TEST INPUT - readiness trace pump panel

PP1

Job number	TEST-001
Company profile	iec-default
Design rules	software defaults, not confirmed by the company's engineers

Company	Project TEST INPUT - readiness tra…	Job number TEST-001	Board	Title of page **Title page**	Rev. A
Date 2026-10-23	Drawn D	Checked	Review approved	Page 1 of 11

Company	Project	Job number	Board	Title of page	Rev.
	TEST INPUT - readiness tra…	TEST-001	PP1	**Main power**	A
Date	**Drawn**	**Checked**	**Review approved**	**Page**	
2026-10-23	D			3 of 11

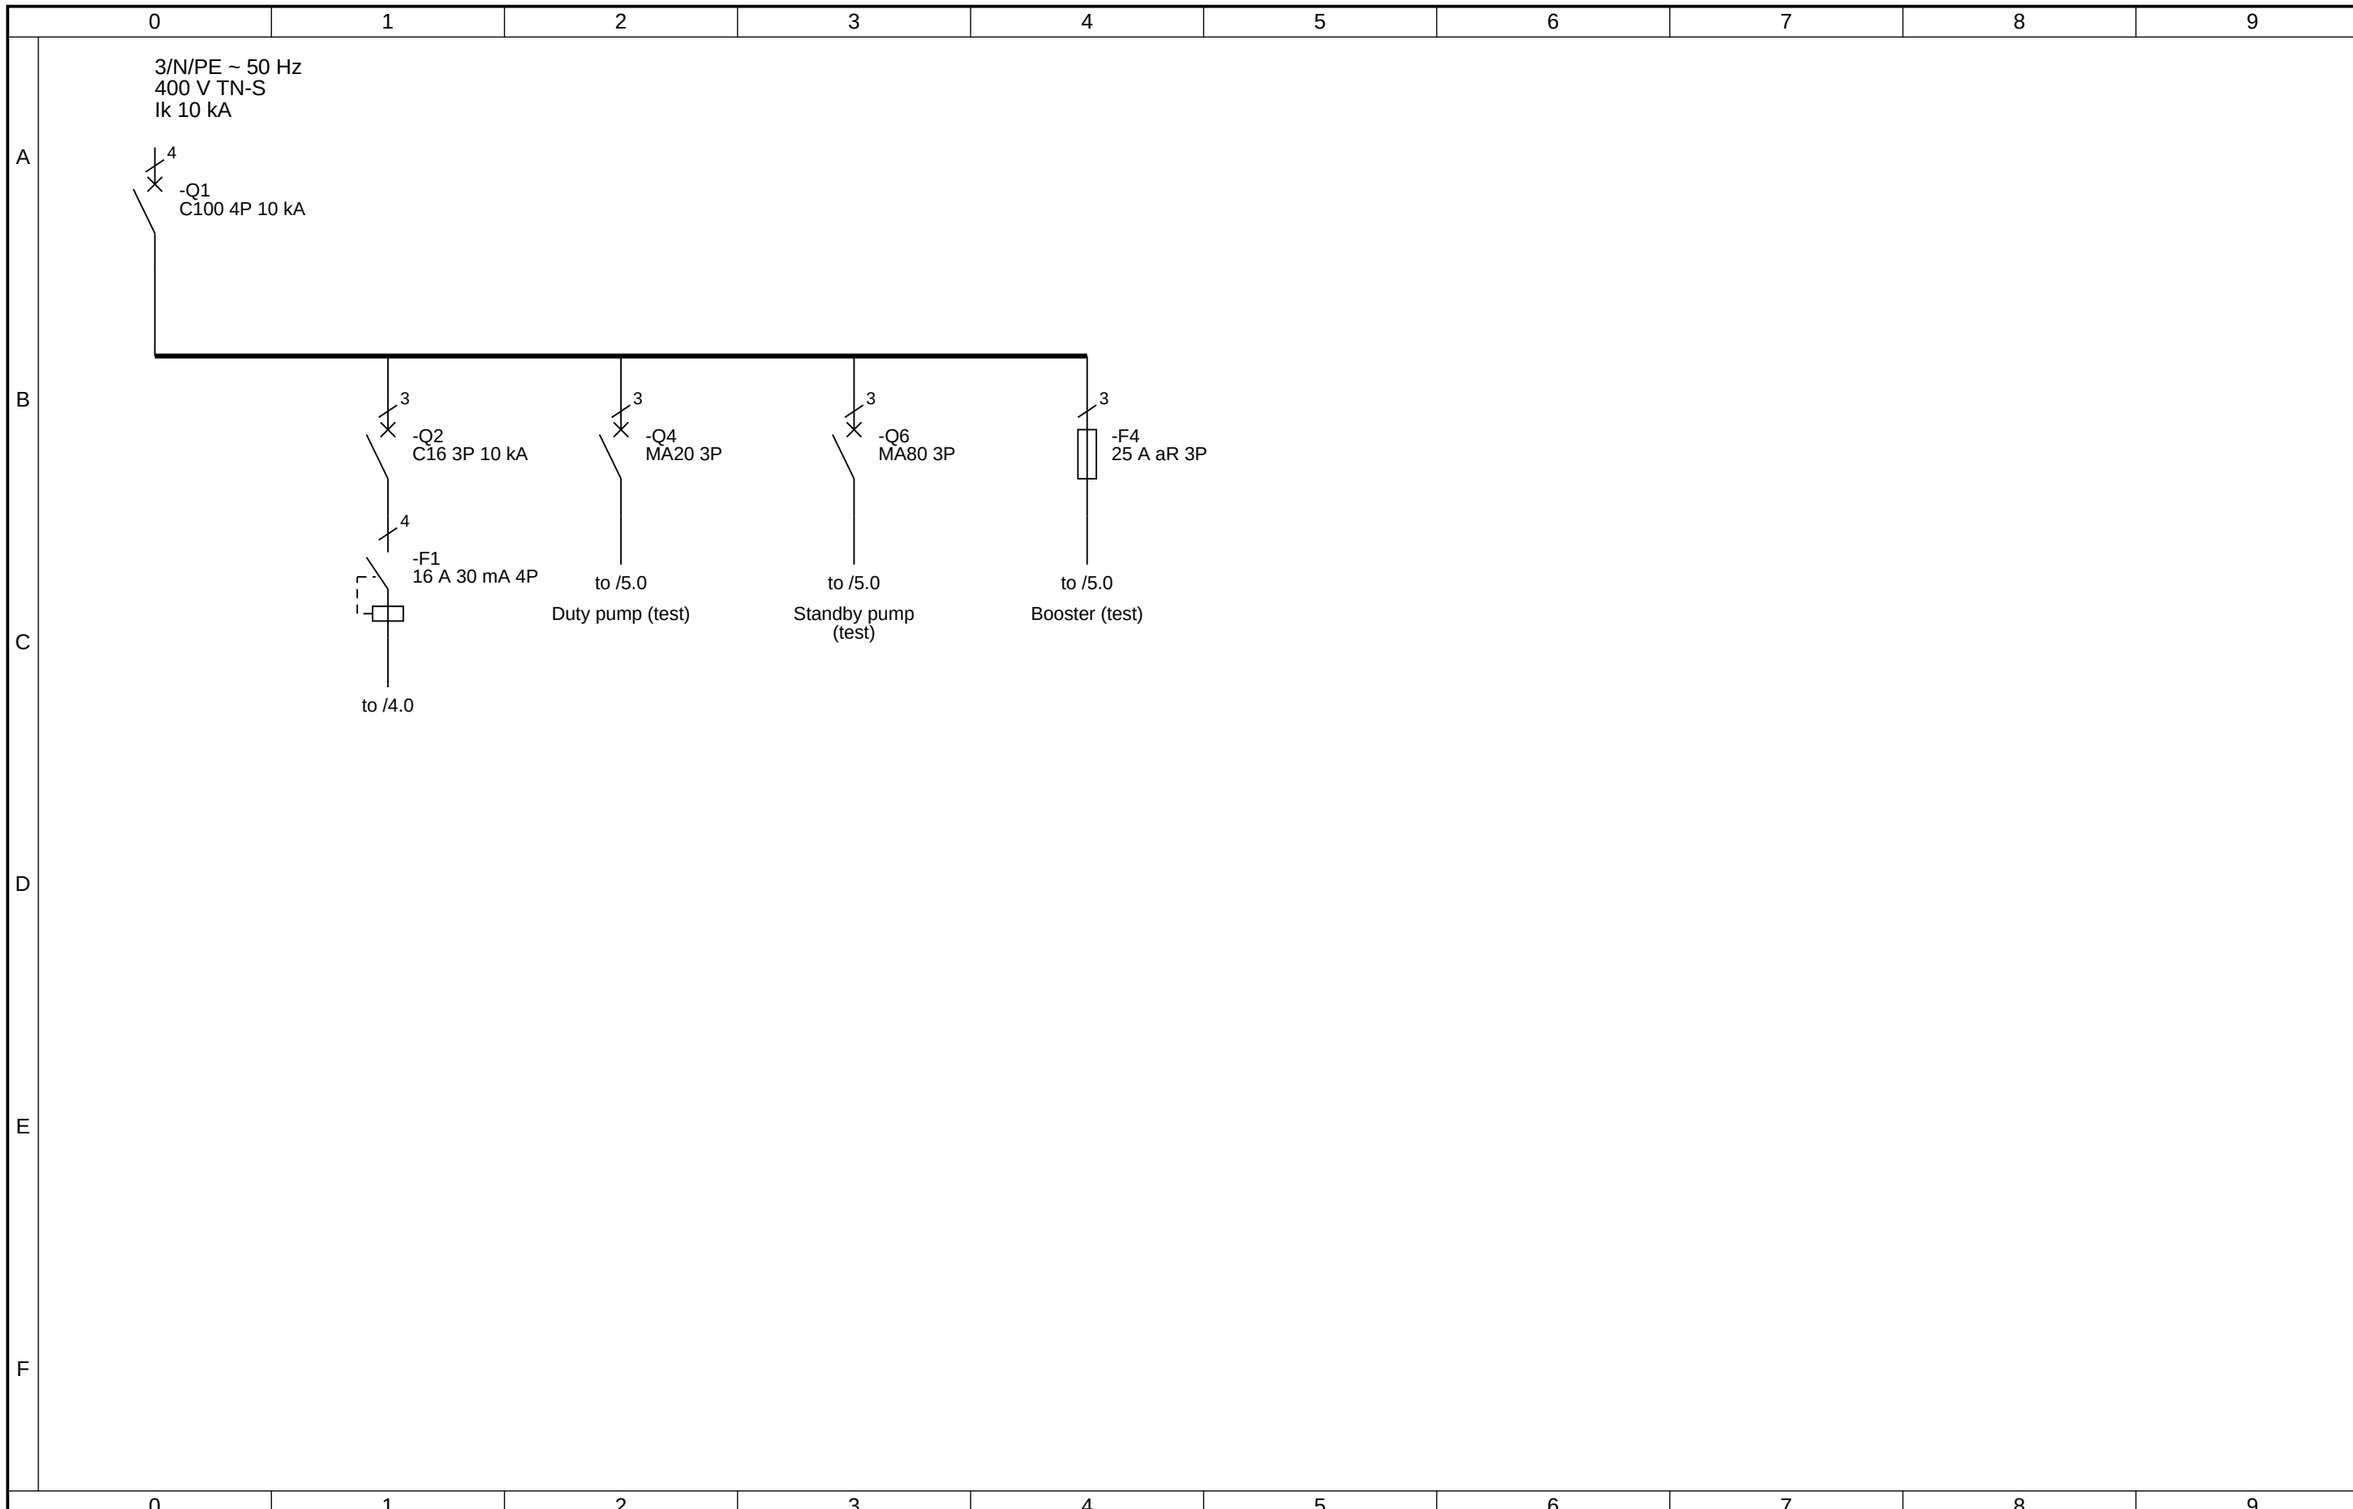
[INFO] PP1: Group 1 breaker raised to 16 A, 1.6 x the 10 A breaker after it, for discrimination. (discrimination_group_raised; source: policy)

Company	Project	Job number	Board	Title of page	Rev.
	TEST INPUT - readiness tra…	TEST-001	PP1	**Distribution loads**	A
Date	**Drawn**	**Checked**	**Review approved**	**Page**	
2026-10-23	D			4 of 11

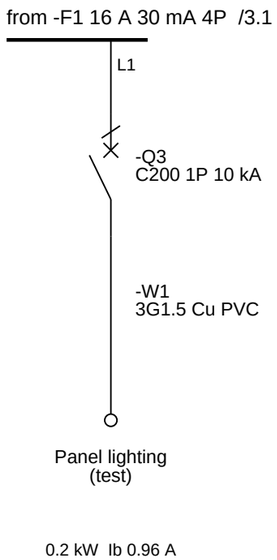
[BLOCKING] PP1 / c1: Panel lighting (test): 200 A protection is above the 17.5 A its 3G1.5 cable carries (method B1); In <= Iz does not hold. (integrity_device_above_cable_capacity; source: ABB Electrical installation handbook Vol. 2, §2.3 (In <= Iz); Iz from §2.2.1 Tables 4, 5, 8)

[WARNING] PP1 / c2: Duty pump (test): Ir 15.2 A, the typical Ir of a 7.5 kW motor in ABB Electrical installation handbook Vol. 2 (1SDC010001D0204), §3.3; check it against the nameplate. (motor_current_table; source: policy; engineering confirmation required)

[WARNING] PP1 / c3: Standby pump (test): Ir 56 A, the typical Ir of a 30 kW motor in ABB Electrical installation handbook Vol. 2 (1SDC010001D0204), §3.3; check it against the nameplate. (motor_current_table; source: policy; engineering confirmation required)

[WARNING] PP1 / c4: Booster (test): Ir 10.38 A from 5.5 kW shaft power at cos phi 0.85, efficiency 0.9; check it against the nameplate. (motor_current_formula; source: policy; engineering confirmation required)

[WARNING] PP1 / c4: Booster (test): the fuses need at least 75 A prospective short-circuit current at the board to operate fast enough. (drive_fuse_fault_level; source: policy; engineering confirmation required)

[INFO] PP1 / c4: Booster (test): the cable after a drive is protected by the drive's motor overload setting, which is not checked here. (integrity_drive_cable_unchecked; source: policy)

[INFO] PP1 / c2: Duty pump (test): dol starter, Type 2 coordination, ABB Electrical installation handbook Vol. 2 (1SDC010001D0204), §3.3 Table 3: 400 V 50 kA DOL Normal Type 2. (starter_table; source: policy)

[INFO] PP1 / c3: Standby pump (test): star_delta starter, Type 2 coordination, ABB Electrical installation handbook Vol. 2 (1SDC010001D0204), §3.3 Table 5: 400 V 50 kA Y/D Normal Type 2. (starter_table; source: policy)

[INFO] PP1 / c3: Standby pump (test): star and delta contactors need a mechanical interlock; the motor is fed by six conductors (U1 V1 W1, U2 V2 W2). (star_delta_interlock; source: policy)

[INFO] PP1 / c4: Booster (test): ACS880-01-12A6-3 for normal duty at 30 °C, behind 25 A aR fuses (ABB ACS880-01 hardware manual (3AUA0000078093)). Use a screened, symmetrical motor cable, earthed 360° at both ends. (drive_selected; source: policy)
